UNITED STATES PATENT AND TRADEMARK OFFICE

APPLICATION NO.	FILING DATE	FIRST NAMED INVENTOR	ATTORNEY DOCKET NO.	CONFIRMATION NO.
10/696,463	10/30/2003	Ming-Tien Lin	237098US-2	6011
22850	7590	11/30/2005	EXAMINER	
OBLON, SPIVAK, MCCLELLAND, MAIER & NEUSTADT, P.C. 1940 DUKE STREET ALEXANDRIA, VA 22314			WANG, GEORGE Y	
			ART UNIT	PAPER NUMBER
			2871

Office Action Summary	Application No. 10/696,463	Applicant(s) LIN ET AL.	
	Examiner George Y. Wang	Art Unit 2871

FIG. 11

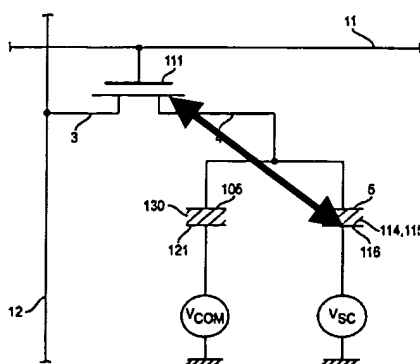
Applicant's only argument is that the secondary reference, Watanabe et al., used in combination with AAPA "does not teach or suggest an LCD having a light shielding layer that is electrically connected to the gate line." Applicant asserts that Watanabe "merely teach[es] that the TFT back channel side conductive light shielding film 140 is connected to the TFT side conductive light shielding film 116. While this is true, it is noted that the claims recite that the first shielding layer is "electrically connected" to the first gate line. Although the light shielding layer (116) is not physically touching the gate line (111) in Fig. 17, the disclosure in the Watanabe reference clearly provides that the gate line (111) is "electrically connected" to the light shielding layer (116) in Fig. 11 (see arrow in the Fig. 11 reproduced below) and in col. 5, lines 1-45.

As a result, Applicant's argument does not place the application in condition for allowance at this time.
